***Central Police Station Conservation and Revitalisation Project  
Baseline and Impact Noise Monitoring Stations***

**Proposed Noise Monitoring Stations**

Location of Noise Monitoring Stations

Figure 1

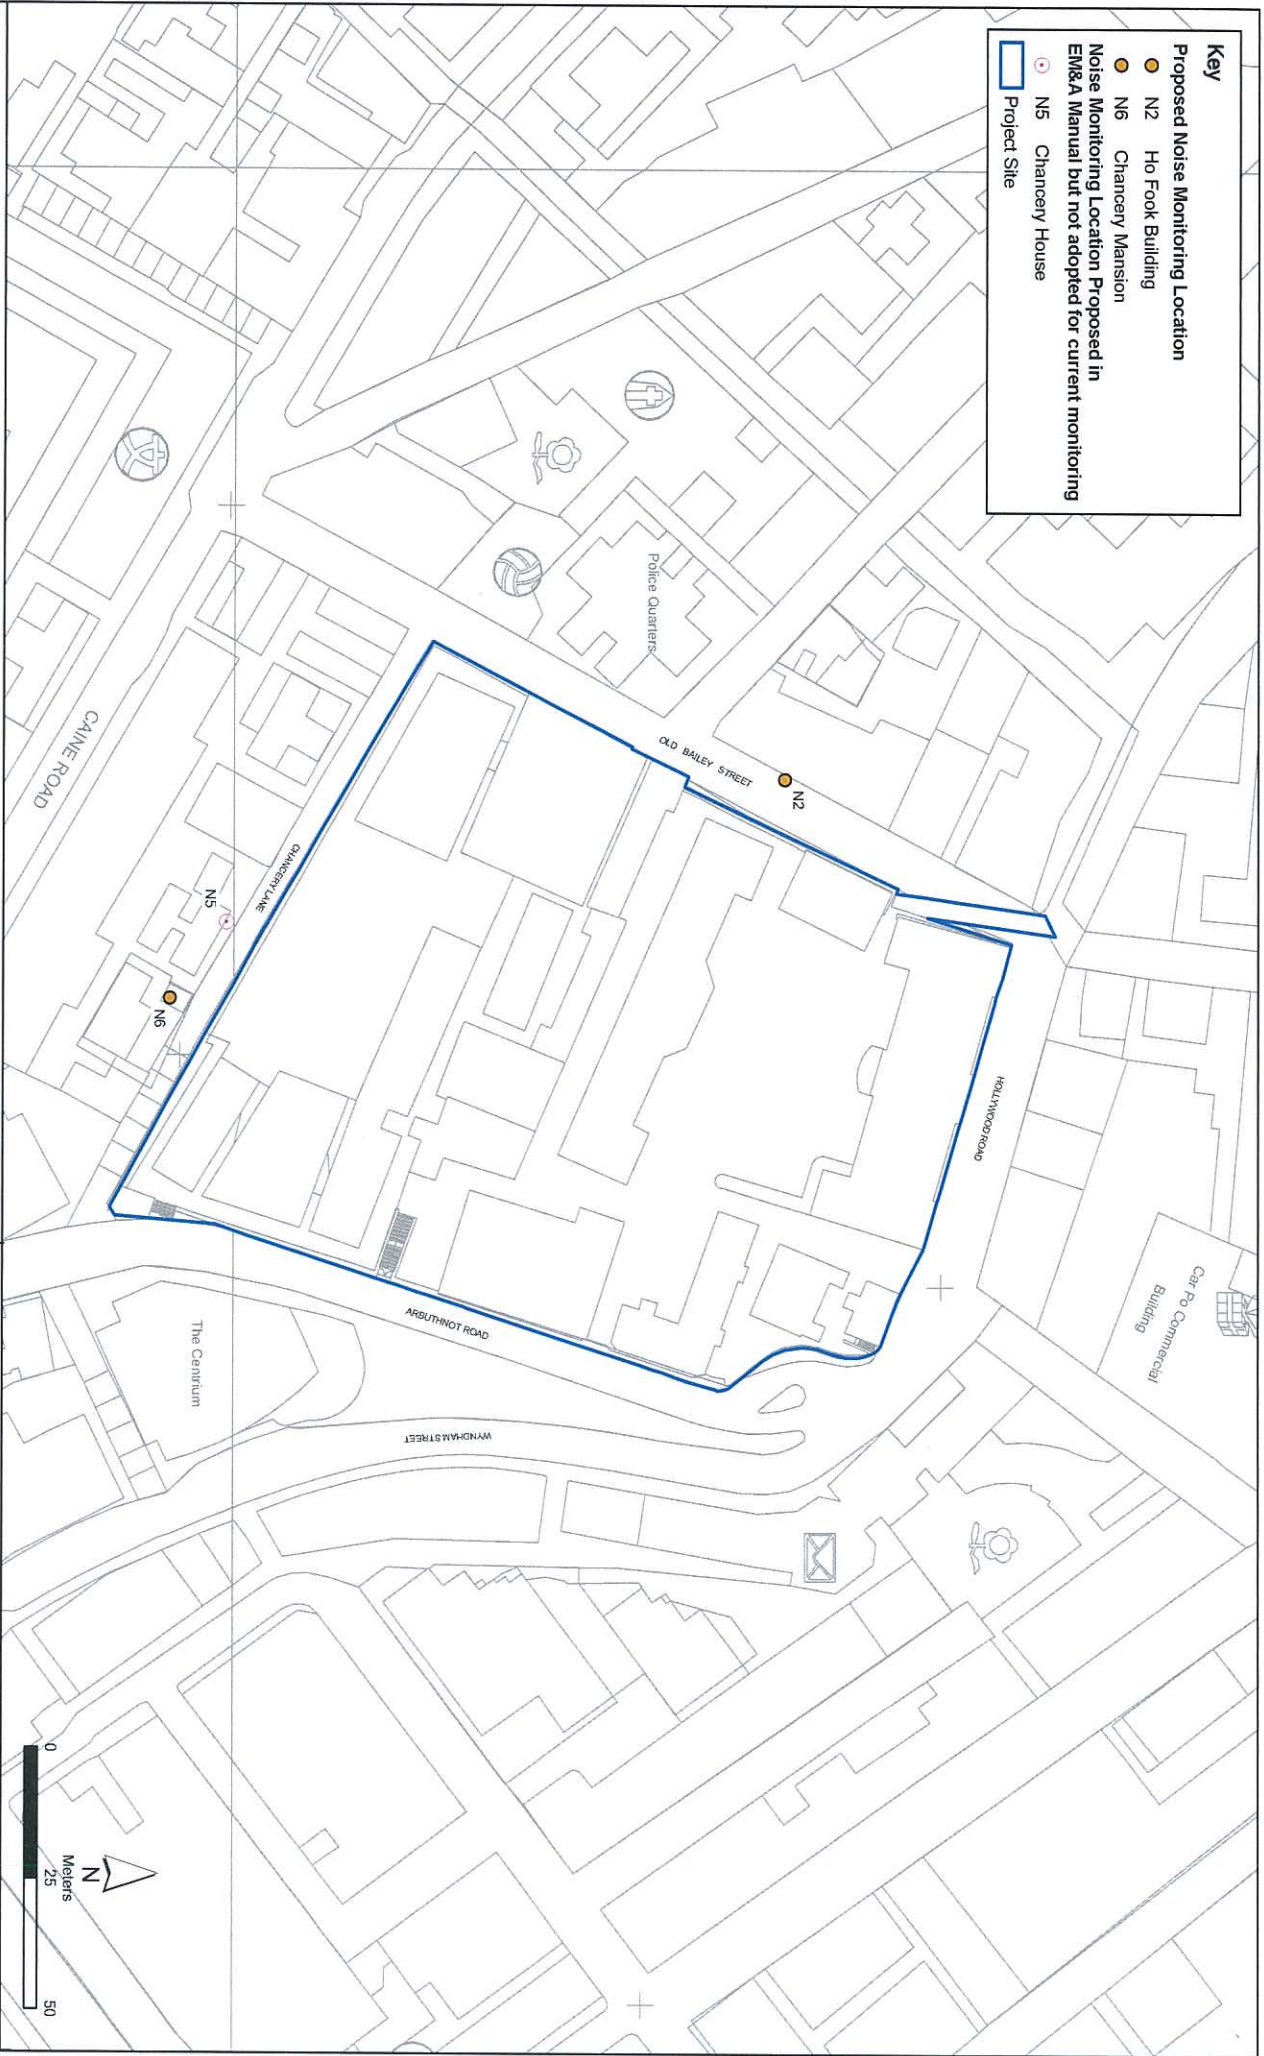
In accordance with the requirement specified in Section 5.4 of the EM&A Manual of the captioned Project, two noise monitoring stations were proposed at Ho Fook Building (N2) and Chancery House (N5), respectively. However, we would like to propose an alternative station at Chancery Mansion (N6) due to the difficulty in granting access of Chancery House (N5). The owner of N5 has rejected our request (see attached rejection letter).

Chancery Mansion (N6) is also an identified NSR in *Table 5.7* of the approved EIA Report (see *Table 1* below). As N6 is the building next to N5, we considered that N6 is also a suitable representative noise monitoring location.

The noise monitoring equipment is proposed to set up at the roof of Ho Fook Building (N2) and 16/F roof of Chancery Mansion (N6), which are shown in *Figure 1*. Photos showing the locations of N2 and N6 are presented in *Figures 2* and *3*, respectively.

We refer to your letter ref.: 0095646\_let\_Atkins\_20110902b.doc dated 2 September 2011 regarding the alternative noise monitoring location for Chancery House (N5). Atkins China Ltd. verifies, in the capacity of Independent Environmental Checker, that the proposed alternative noise monitoring location at Chancery Mansion (N6), in principle, conforms the requirements provided in Section 5.4 of EM&A Manual.
